# **Identification of Producibility Inhibitors in Standard NAVSEA Ship Design Practices**

**Newport News Shipbuilding**

TANGENTIAL VENT FTG SILBRZ, SWLD OR BTWLD  
VENT SHOWN ROTATE 180° FOR DRN

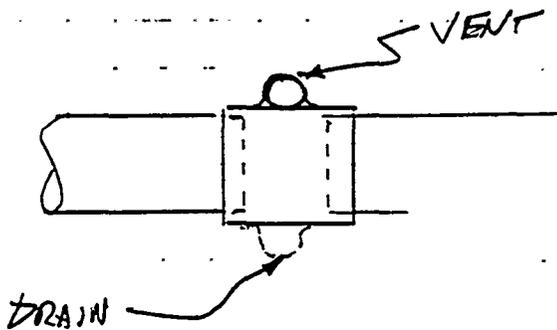
**PROBLEM STATEMENT:** The use of globe valves for high pressure and low pressure vent and drain systems is more expensive than the alternative discussed below.

**ADDITIONAL COMMENT:** The simple fitting shown in the accompanying sketch would be much less expensive to manufacture and install than globe valves.

**PROPOSED SOLUTION:** Develop a low pressure tangential vent and drain fitting similar to the high pressure vent and drain fittings used on submarine hydraulic systems, and use these type fittings in all fluid systems..

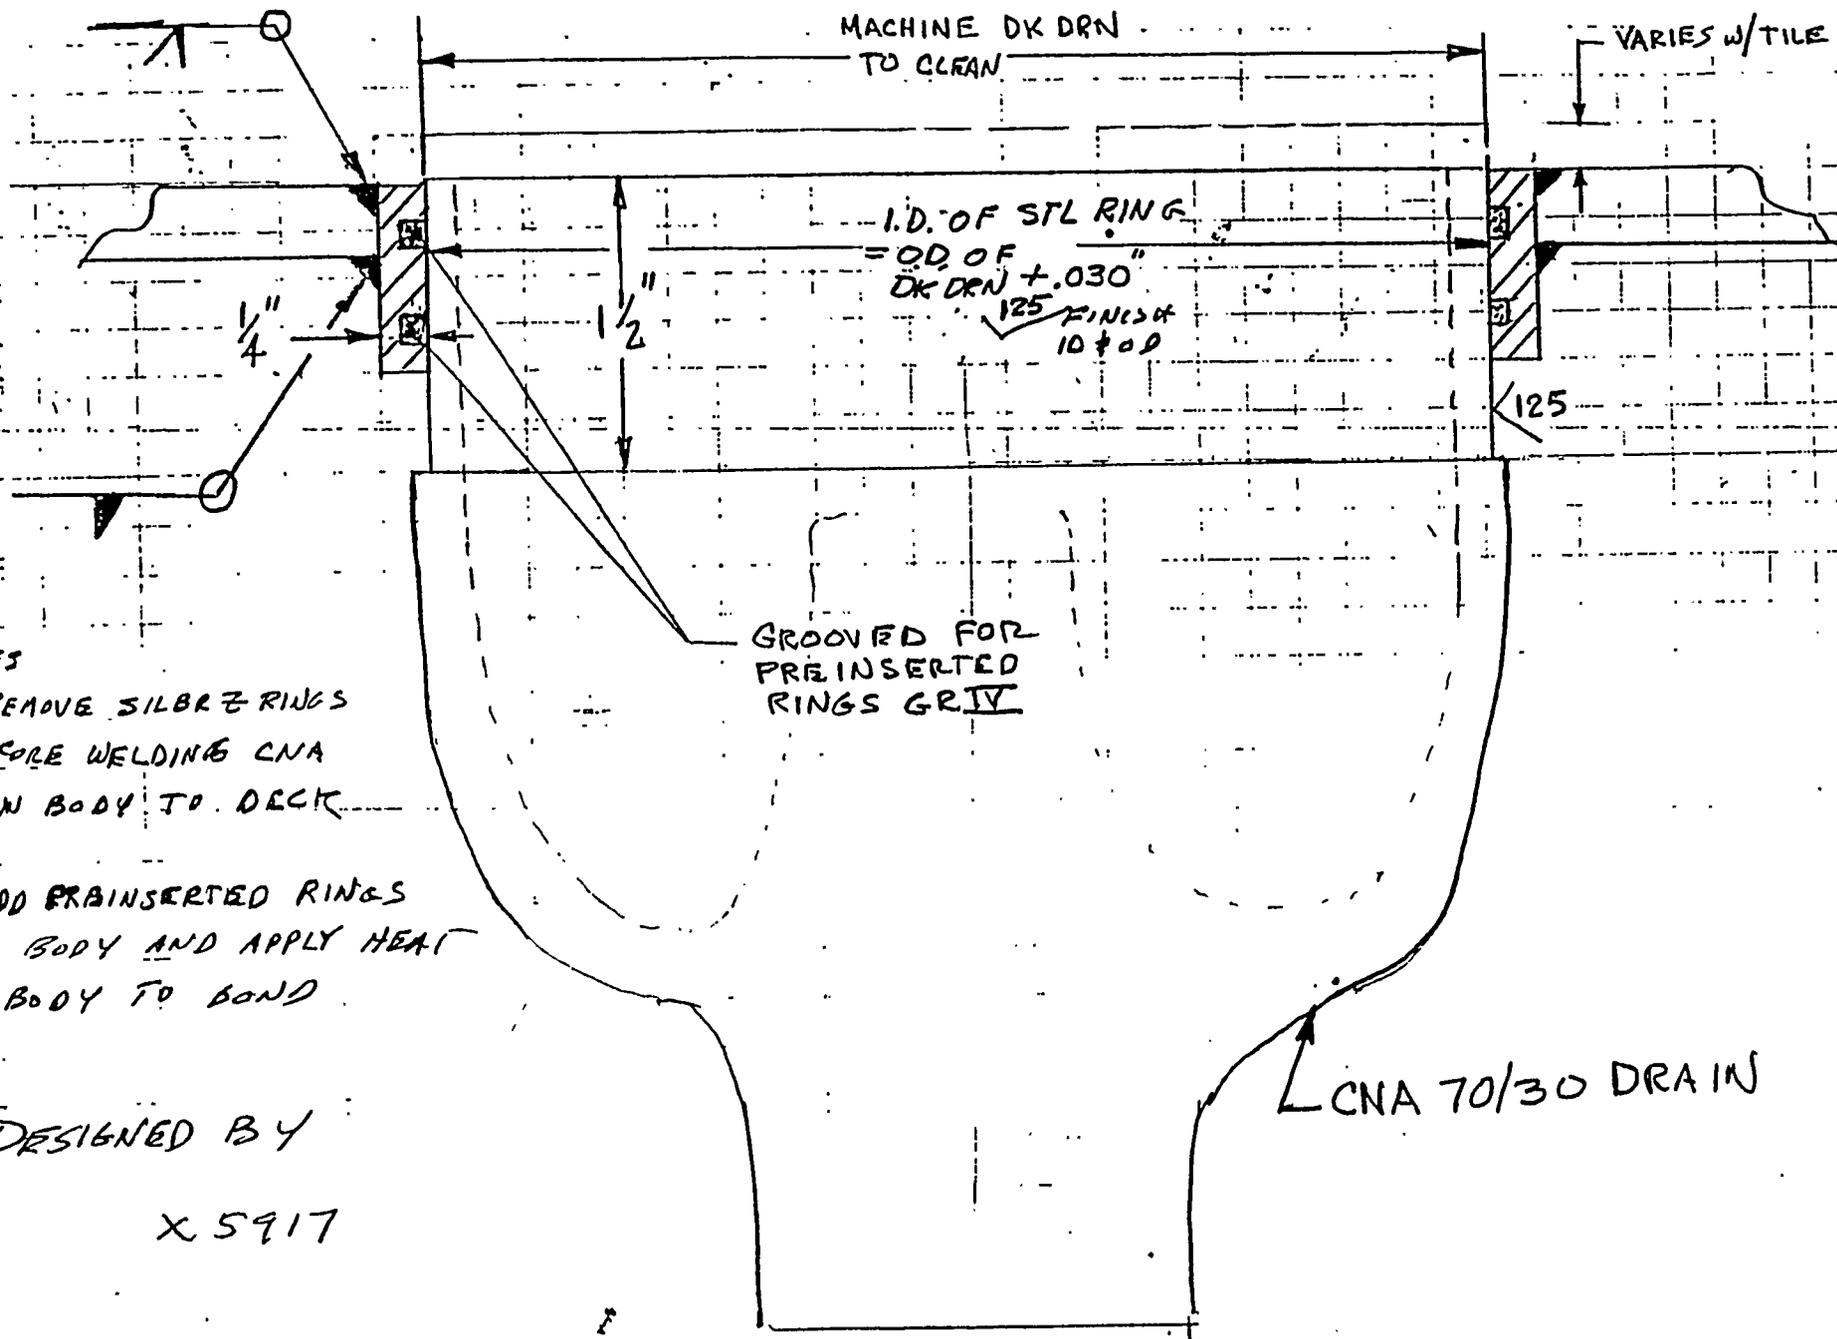
**PROBLEM STATEMENT:** The drains designed to the standard drawing referenced above are leaking around the steel rings.

**PROPOSED SOLUTION:** Develop CNA drains with 4" seals and steel ring for welding into the deck for strength and silbrazed the deck drain into the ring with grade IV solder.

MODIFIED 2" DK DRAIN W/4" SEAL

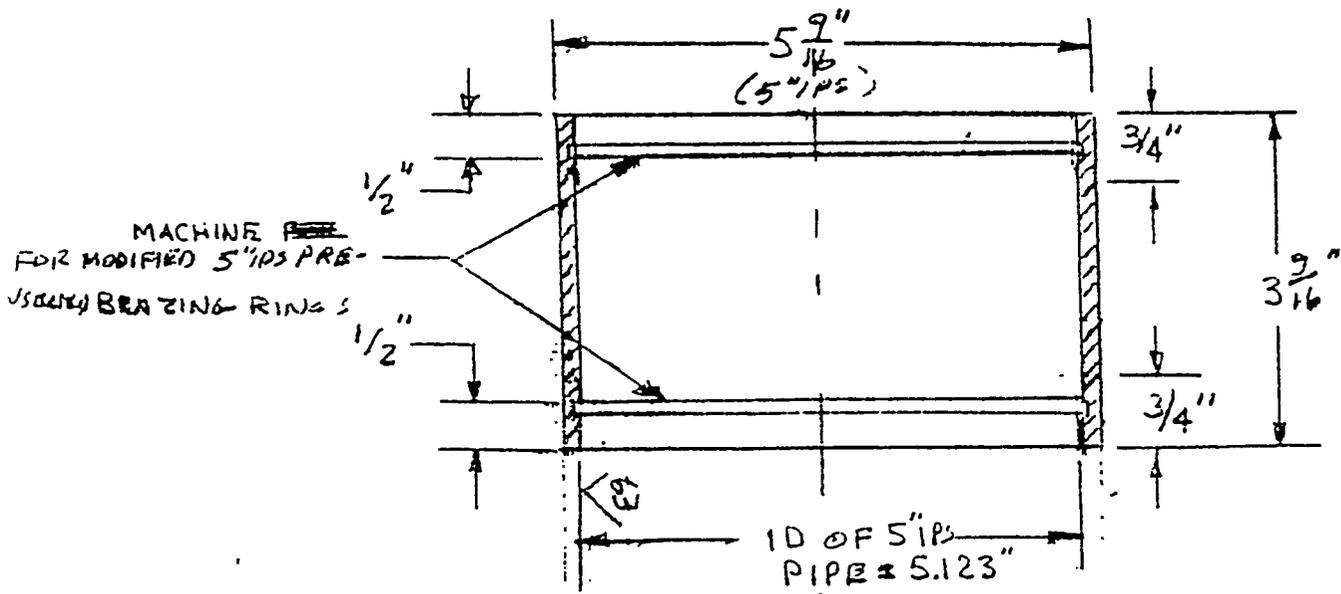
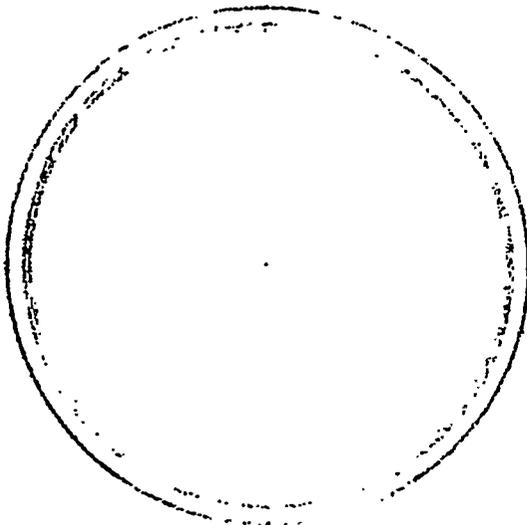
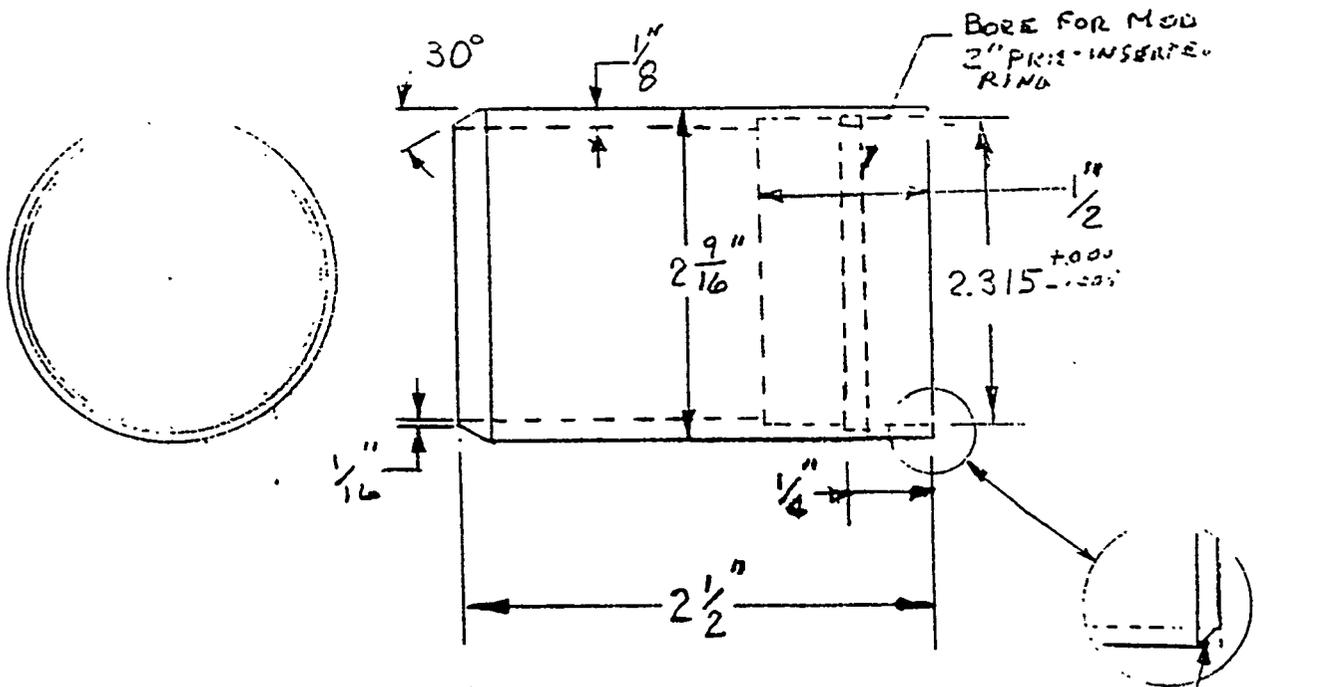
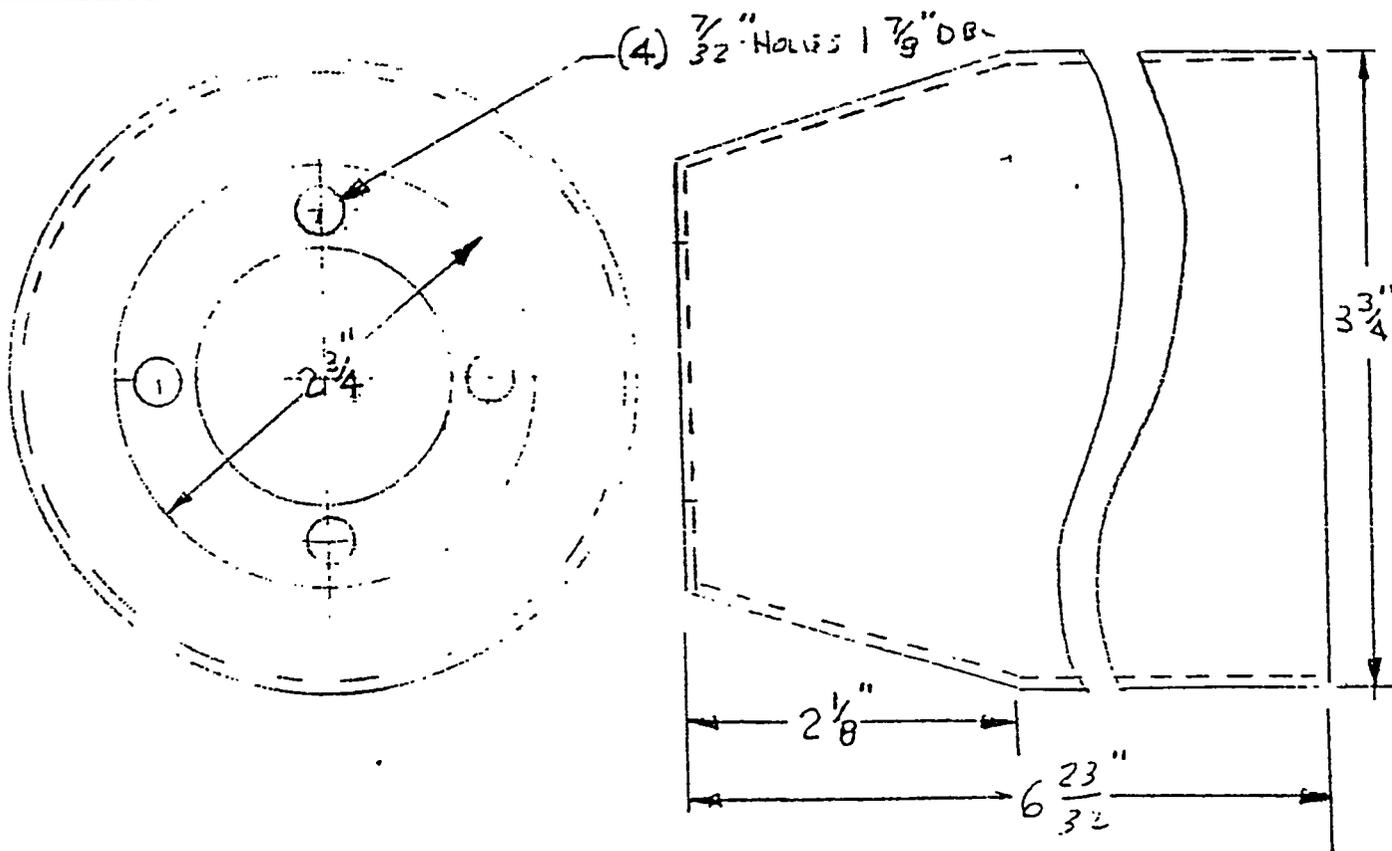
**PROBLEM STATEMENT:** "P" traps now have to be added in drain rings for CPS systems. These have to be oriented fore and aft, which affects design and installation.

**ADDITIONAL COMMENT:** Design time and installation time will be reduced. See attached sketch for proposed changes.

**PROPOSED SOLUTION:** Modify existing deck drains or manufacture new ones to suit 4" seals.
